MONTGOMERY COUNTY HISTORIC PRESERVATION COMMISSION
STAFF REPORT

Address:	21 Grafton St., Chevy Chase	Meeting Date:	7/10/2019
Resource:	Contributing Resource Chevy Chase Village Historic District	Report Date:	7/3/2019
Applicant:	Duane and Paula Gibson (Doug Mader, Architect)	Public Notice:	6/26/2019
Review:	HAWP	Tax Credit:	No
Case Number:	35/13-19DD	Staff:	Dan Bruechert
PROPOSAL: Building Addition and other alterations

STAFF RECOMMENDATION

Staff recommends the HPC approve the HAWP application with one (1) condition:

Figure 2: Rear lot of the subject property showing the encroachment of house additions and outbuildings at the rear.

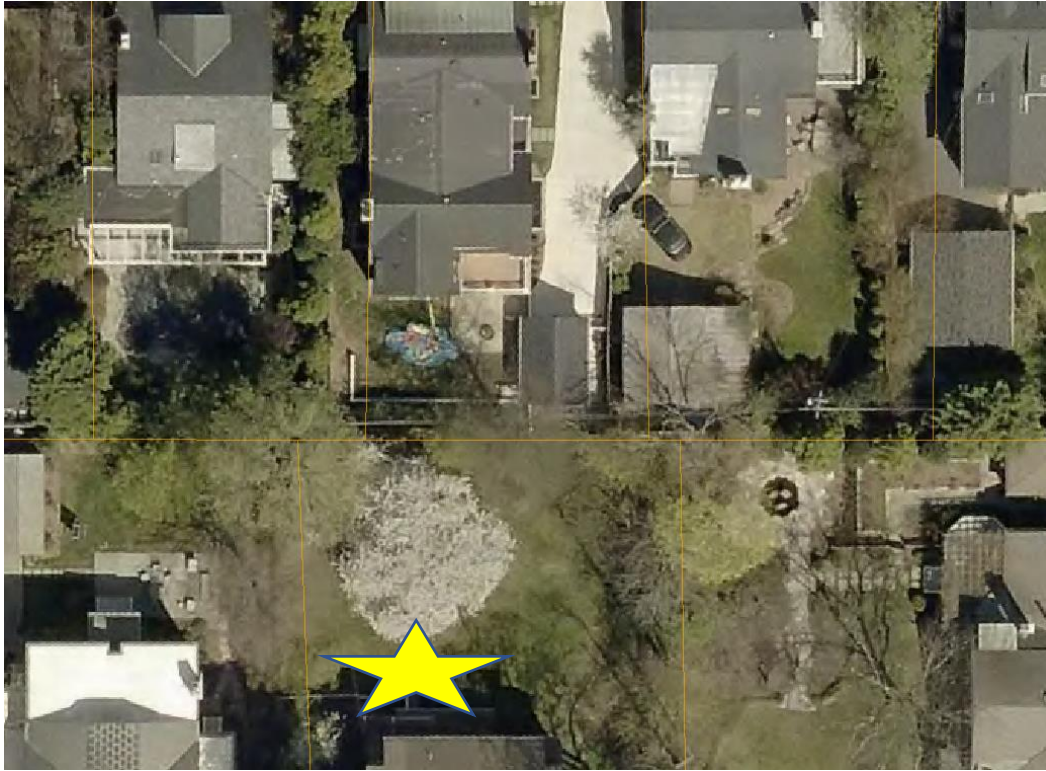
Staff finds the impact of these buildings is not effectively transmitted in the map and photograph included in this Staff Report, but that it does create a sense of being closed in and an addition that projects further to the rear would only compound that sensation. Additionally, the

house to the east, 19 Grafton, is on a double lot, which leaves a large open expanse between it and the subject property (see Fig. 2, above). Regardless of whether the addition projects 6' (six feet) or is inset from the historic wall plane, it will be highly visible from the right-of-way to the east. The 80' (eighty foot) setback between the subject property and its neighbor to the east will make any rear addition highly visible from the right-of-way. This partially frustrates the purposes of the *Design Guidelines* for requiring additions to be placed to the rear of the historic buildings to make them less visible from the right-of-way, because any addition to this house will be highly visible from the right of way.

Design Development
Architectural
Site Plan

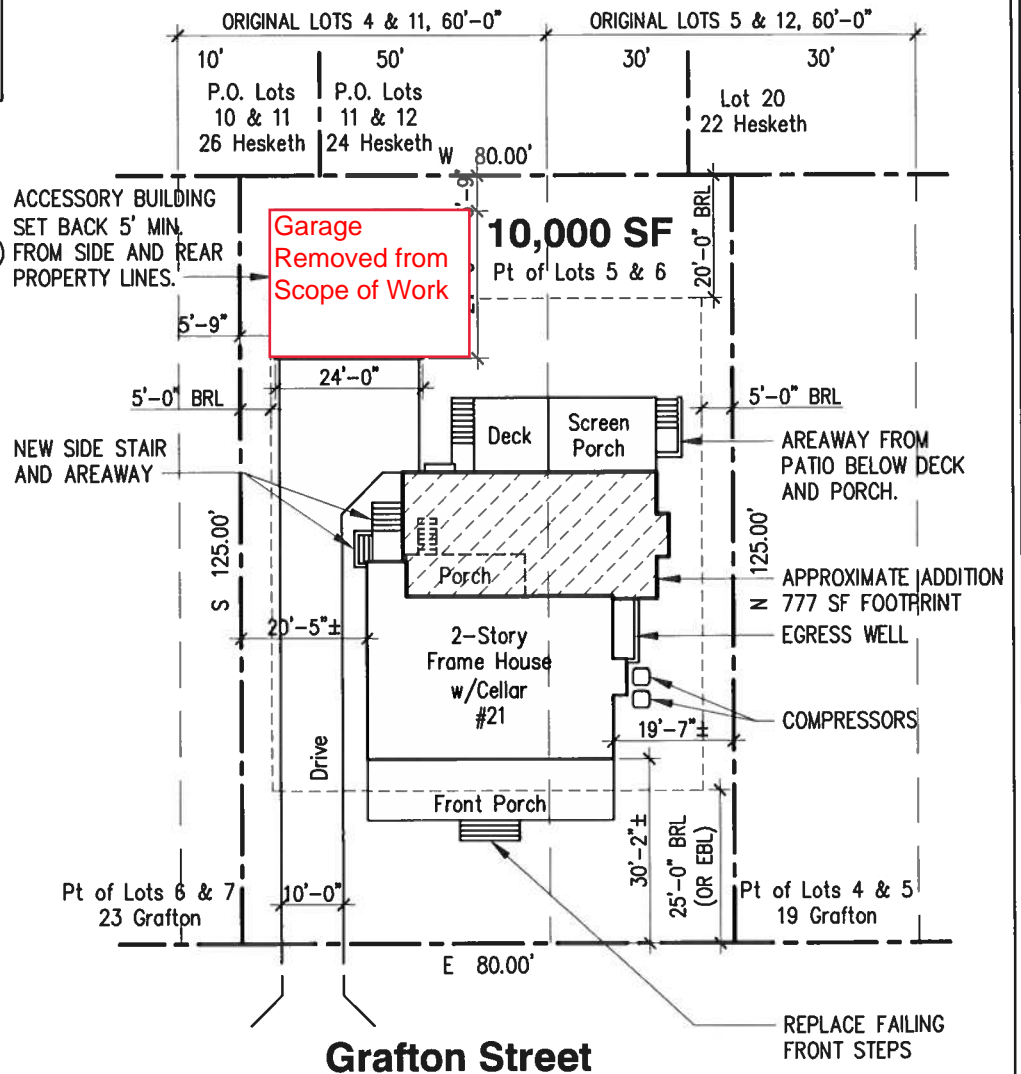
Finally, lot coverage on historic buildings in the Chevy Chase Village Historic District are to be reviewed under strict scrutiny in view of the open, park-like setting. Lot coverage will be increased, but no trees will be impacted by the proposed addition and rear porch.

**Design Development
Front Elevation**

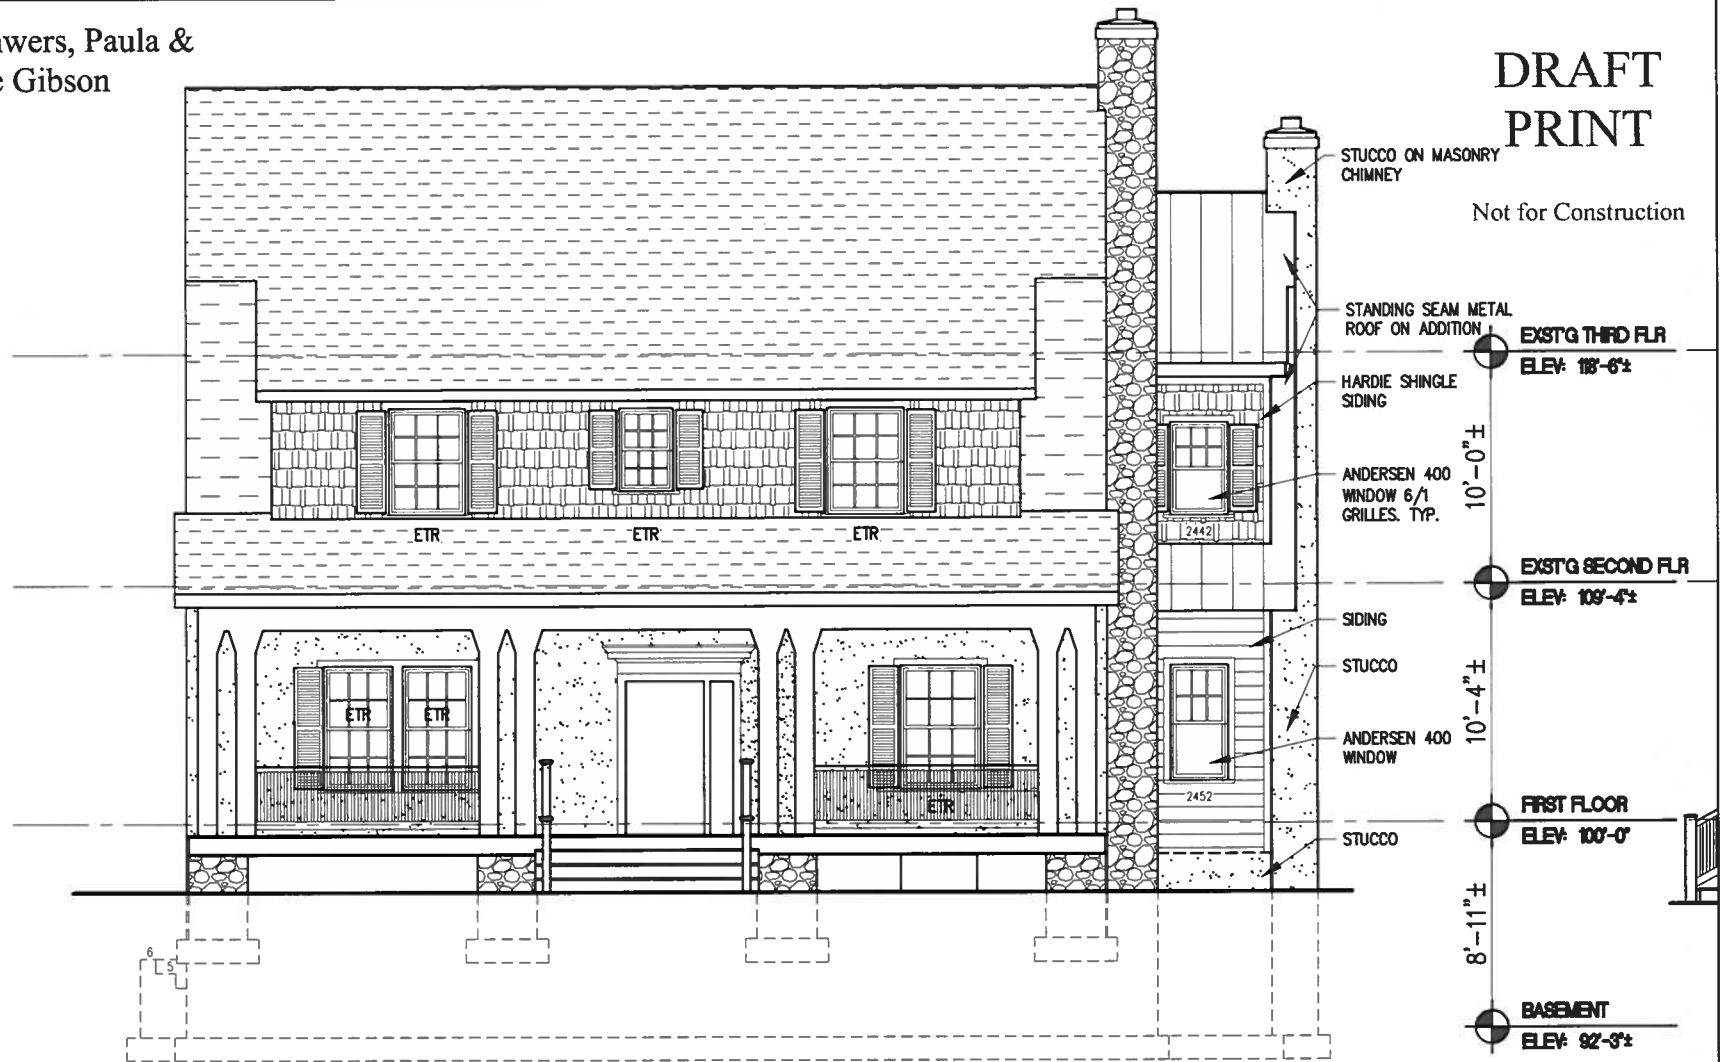
The second proposed change is to replace the front porch steps with code-compliant steps in wood. The submitted drawings show new stairs and a railing to match the existing railing. Staff finds that with this alteration will not have a significant impact on the historic character of the house or surrounding district (per 24A-8(b)(2)).

Design Development
Rear Elevation

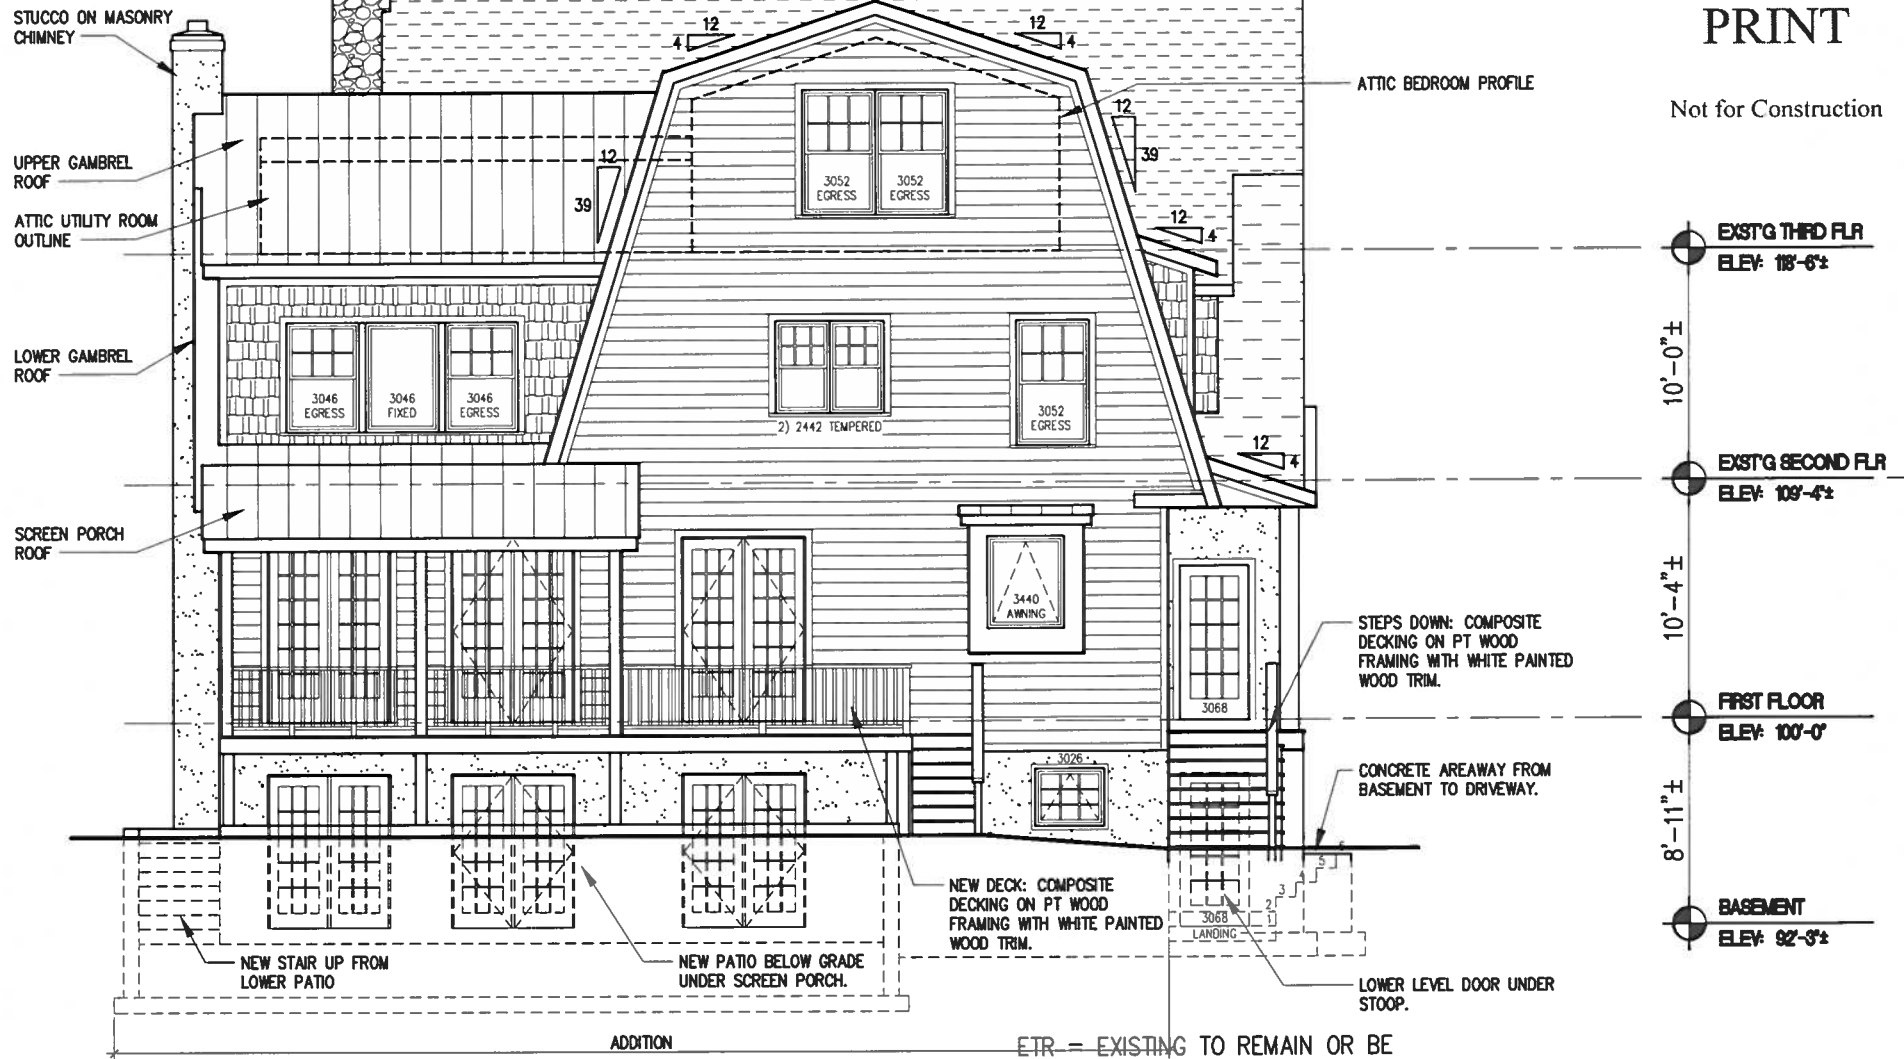
The previous proposal called for a butterfly or double gambrel roof with a ridgeline that matched the historic ridge. In response to near unanimous feedback from the HPC that the form needed to be lowered to reduce the mass and be deferential to the historic construction, the applicant revised the form of the addition. The new form has a larger rear-facing gambrel that is one foot below the historic gambrel ridge. The right-facing gambrel is now 4' (four feet) lower than the historic gambrel to reduce its visual impact. To further explain the roof configuration, the applicant included the requisite roof plan.

At the rear of the proposed addition, the applicant is proposing to construct a screened in porch with a shed roof. The decking will be wood with simple wood posts supporting the shed roof. The simple porch design, at the rear is an element that should be approved as a matter of course.

Chevy Chase Village *Design Guidelines* require the proposed rear addition to be reviewed under ‘moderate scrutiny.’ Staff finds under this requirement, the massing, scale, and architectural capability of the proposed addition are compatible with the historic construction. Staff finds that the size of the proposed addition, with a footprint of roughly 800 ft² (eight hundred square feet) is in proportion of the subject property and surrounding historic district.

As the HPC did not reach a consensus on appropriateness of a right projection, Staff has analyzed the proposal and finds that the reduction in scale and mass in the design presented, along with the unique lot characteristics, make a side projection appropriate in this instance. Furthermore, the applicant worked with Staff to revise the design of the side-projecting gambrel form to a more compatible form that is closer in pitch to the historic gambrel. Staff finds nothing proposed in this HAWP would put the altered structure’s ‘contributing’ significance at risk.

Staff finds that the majority of architectural details and the design of the proposed addition is compatible with the historic architecture at 21 Grafton St. The use of fiber cement siding will introduce one new material to the building, but Staff finds it will sufficiently differentiate the new construction from the historic. Stucco on the foundation and chimney will tie the two phases of construction together. Staff, however, finds that fiber cement shingles in the gambrels will have too flat of an appearance to be compatible with the shingle siding on the house and should be a wood shingle. Staff recommends the HPC include a condition for approval that the shingles on the addition are wood, to be verified by Staff on the permitting plans.

- 1) **Massing and Scale.** The Prior Proposal involved two rear-facing gambrels the same height as existing structure. **The Revision drops the roof height of the rear-facing right gambrel by 6 inches (looking from rear of house), eliminates the left rear-facing gambrel, and adds a smaller, shorter side (east-facing) gambrel from the new space. Further adjustments were made to change the pitch of the roof facing east per HPC staff recommendations. This cleans up and squares the new structure with the old when viewed from the front. This removes Prior Proposal's angular facings on the new space viewed from the front elevation.** This accommodates concerns of (a) massing and scale from the east side (and front), which are greatly reduced, (b) a duplicate fireplace smokestack, which is shortened substantially due to lower roof height and includes material change to stucco from stone (in direct response to commissioners' comments), and (c) gambrel angles on the east side when viewed from the front. This also partially addresses how the new structure joins with the existing structure in a more cohesive way.

- 3) **Complexity.** The comments about the rear elevation was that it was "complex and confusing." **The Revision with only one rear facing gambrel and the smaller side gambrel rectifies larger "the projection" to the east side and to the rear by its new, simpler nature. Additionally, the rear eating area "bump out" has been eliminated, further simplifying. A roofed screen porch and unroofed area were maintained (but stairs down from the porch are put behind the house, not on the east side). Materials also simplify and**

1. Shingles in the gambrels on the proposed addition need to be wood to match the shingles on the house.
